ADDENDUM NO: 03

DATE: **Thursday – November 19, 2026**

PROJECT: **MSU Hamilton Hall Life Safety System Improvements** Bozeman, Montana

1 LEVEL 4 - FINISH PLAN
3/16" = 1'-0"

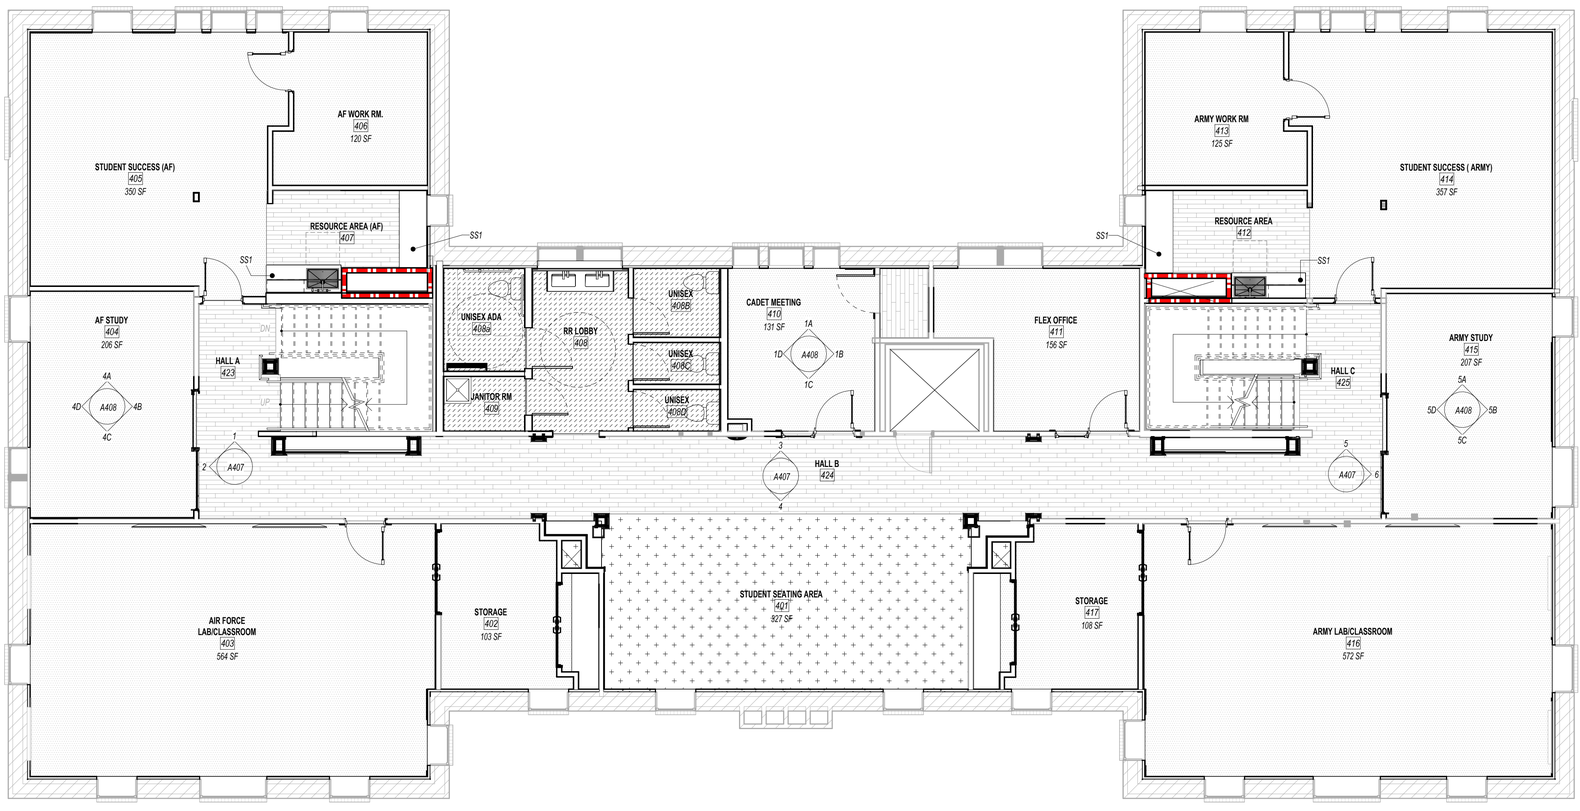
21. Question: Is FRP needed at the Janitor Room mop sink? Response: Yes, provide FRP around sinks. See revised Sheets A702 and A703.

32. Clarification: See attached revised Sheet A703 finish schedule to clarify finishes in Janitor's Room 409.

10. **Sheet A403 –** See revised stair and handrails.
11. **Sheet A407 –** See revised 4th floor – Enlarged plans and interior elevations.
12. **Sheet A601 –** See revised Door & Window Types, Door Schedules.
13. **Sheet A702 –** See revised 3rd Floor Finish & Schedule.
14. **Sheet A703 –** See revised 4th Floor Finish & Schedule.

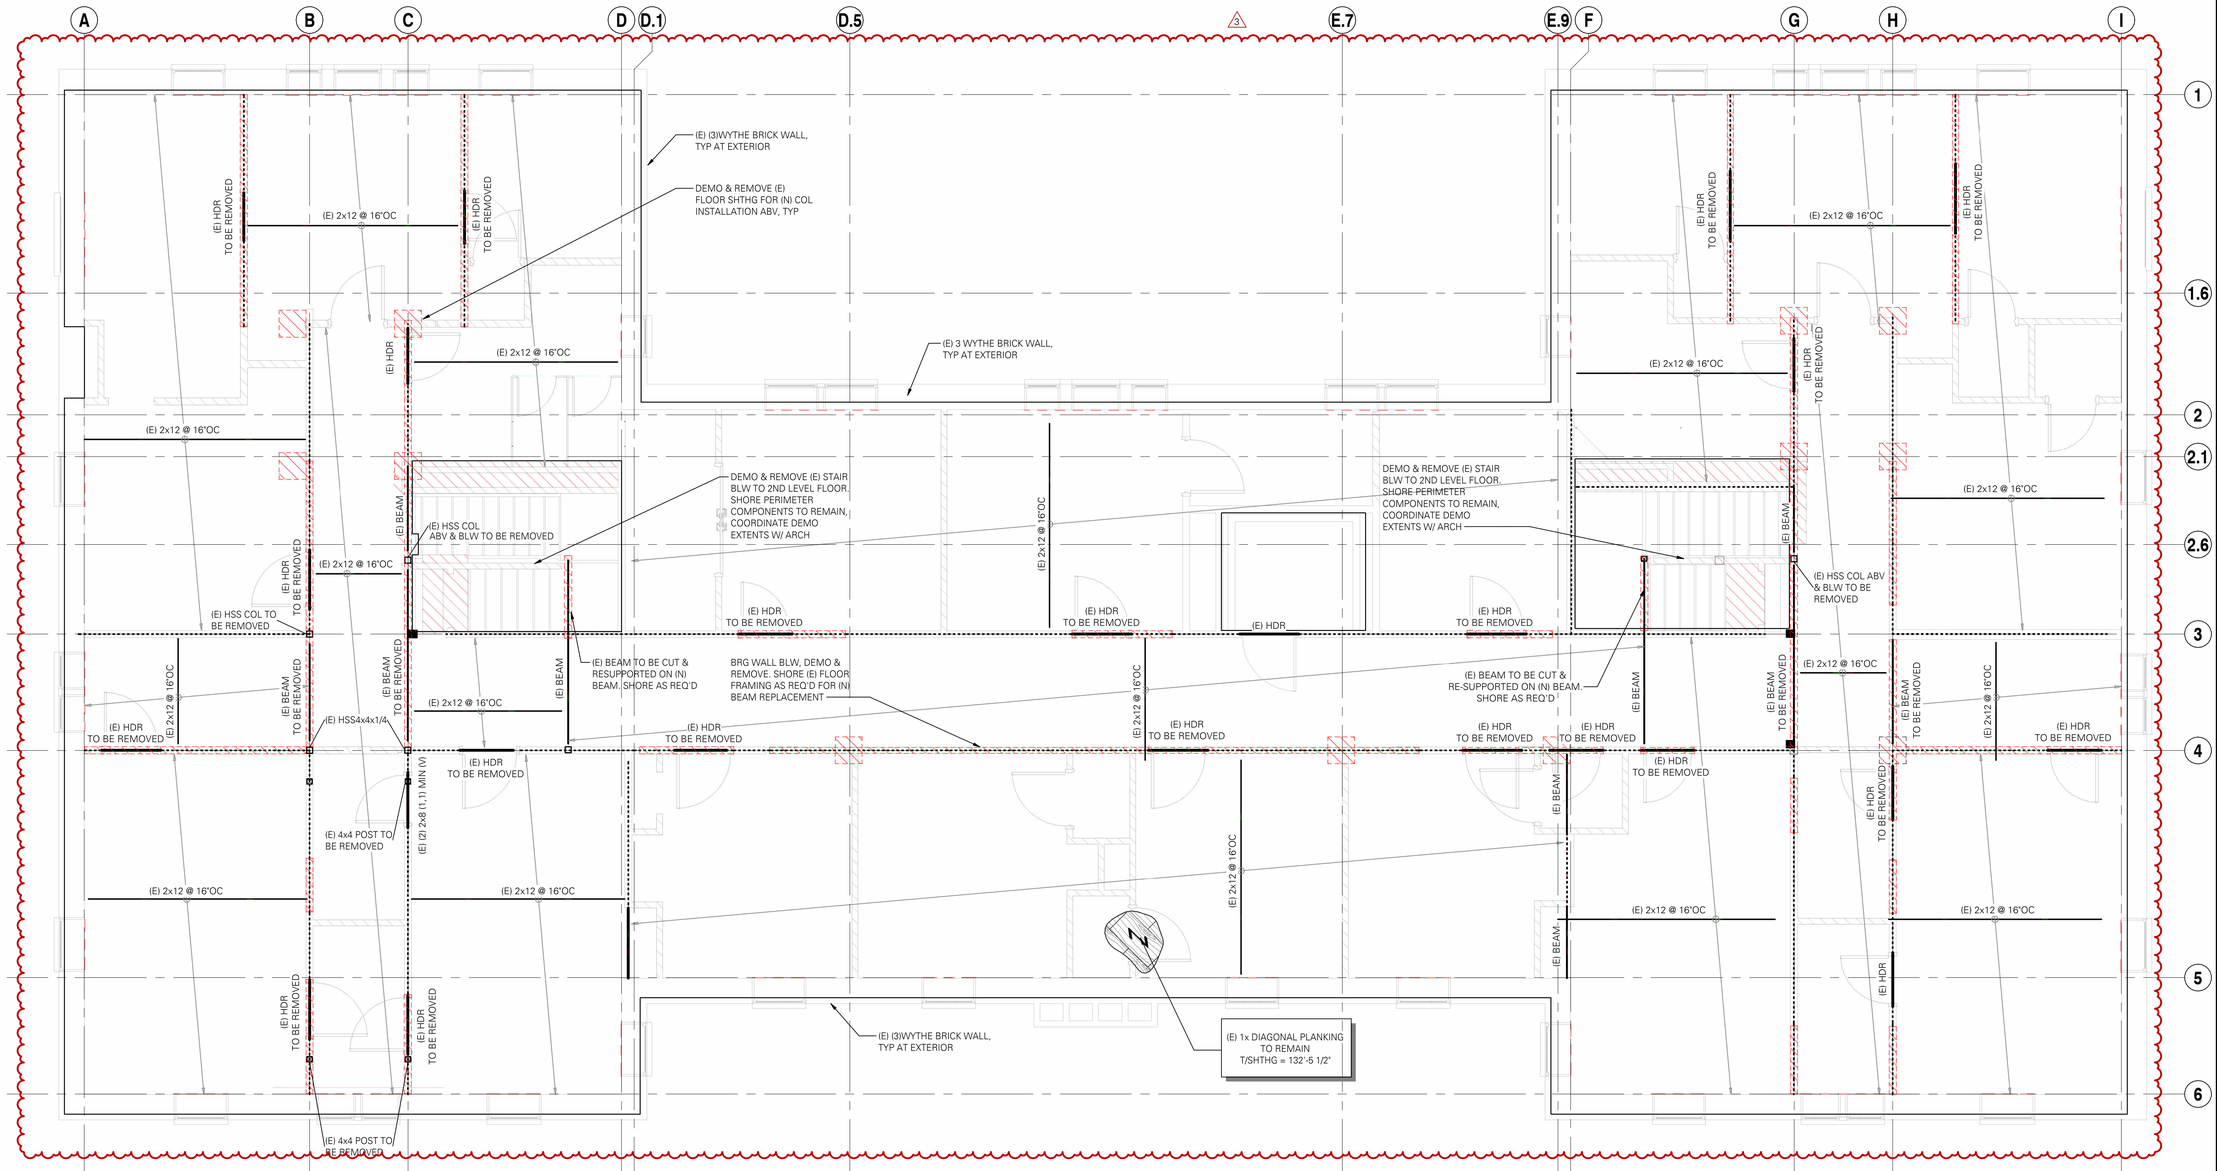
40. Question: The structural demolition plan appears to have a bunch of dashed beams that are not specifically called out to be removed. In some cases, there is a new beam going in those locations, in others, there appears to be no new structure. Could you please clarify which structural components need to be removed. Response: See attached revised Sheet S102.

1. **Sheet S102 –** See revised sheet.

EL000

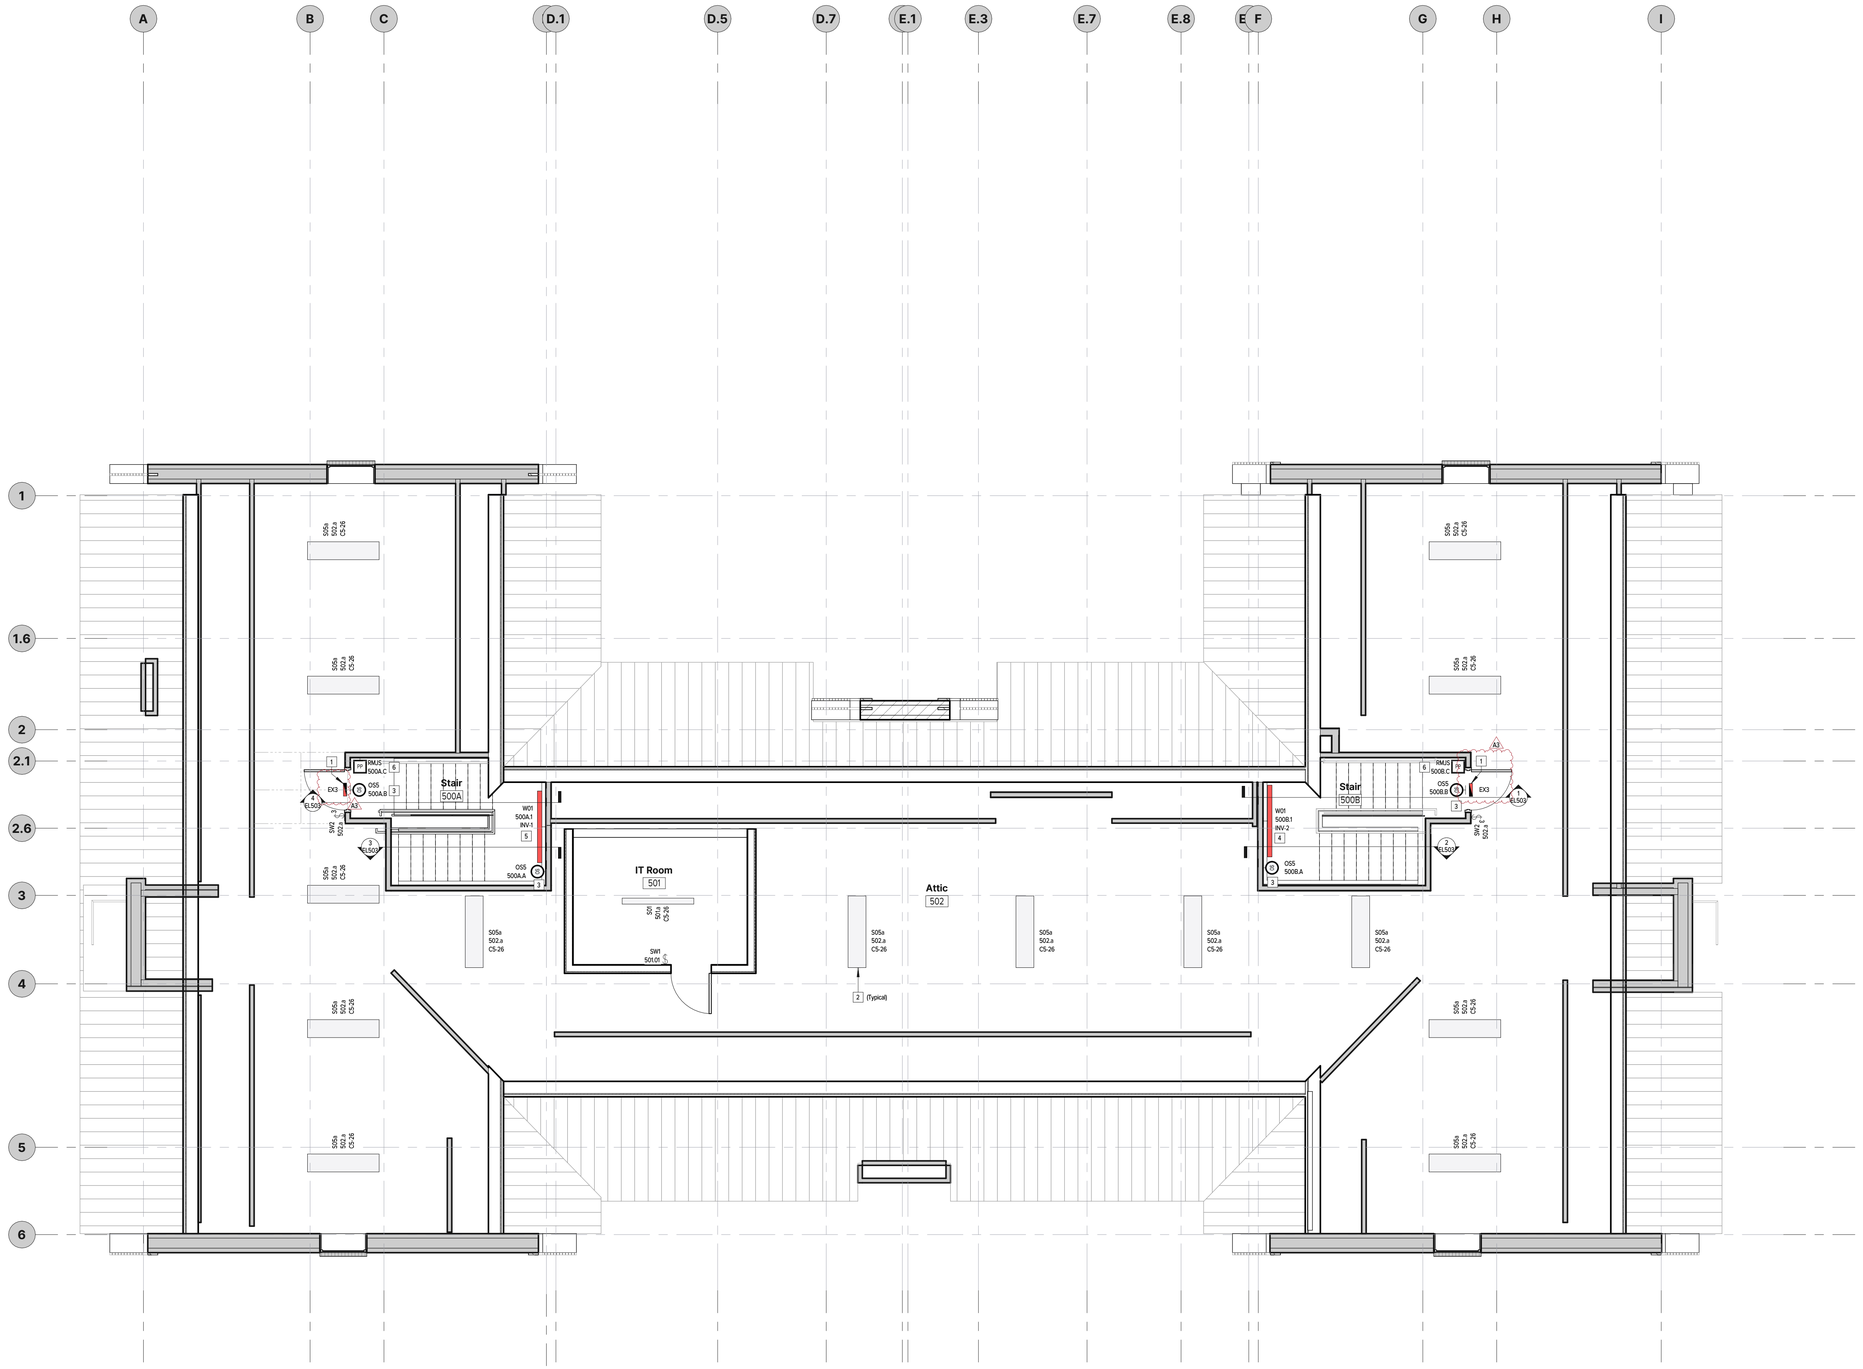
2. The specifications call for battery-powered exit signs while the drawings indicate a central inverter. Please confirm the desired option. Response: Battery-powered exit signs (Type EX3) will only be located in the attic. Edge-lit-exit signs on Levels 3 and 4 (Type EX1 and EX2) require AC power from the inverter. Luminaire schedule is correct but understood on confusion in the attic as we showed an inverter tag – those will not be connected to central inverter, refer to keynote # 1 on EL119.

3. **Sheet EL119** – Clarification added to keynote #1, and incorrect INV tag was removed. Exit signs in Attic are battery powered and should be connected to the nearest unswitched hot electrical circuit.
